**REMARKS**

This Application has been carefully reviewed in light of the Final Office Action. In order to advance prosecution of this case, Applicant amends Claims 40, 42, 43 and 47. Applicant cancels Claims 34-39, 41, 44-46 and 48-50, without prejudice or disclaimer. Applicant adds new Claims 51-64. Applicant respectfully requests reconsideration and favorable action in this case.

FIG. 10  
(Prior Art)

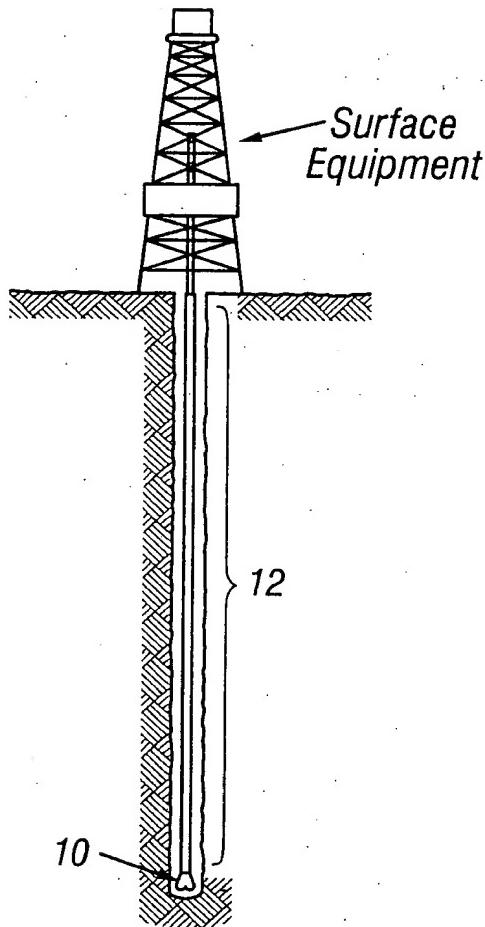
The Office Action objected to the drawings and required that Figures 10-12 be designated by a legend such as "Prior Art". Applicant includes with this Response proposed revisions to page "8 of 8" of the drawings in which Figures 10-12 have been labeled as "Prior Art" (see Exhibit B attached), for approval by the Examiner. Thus, Figures 10-12 have been labeled "Prior Art", as required by the Office Action.
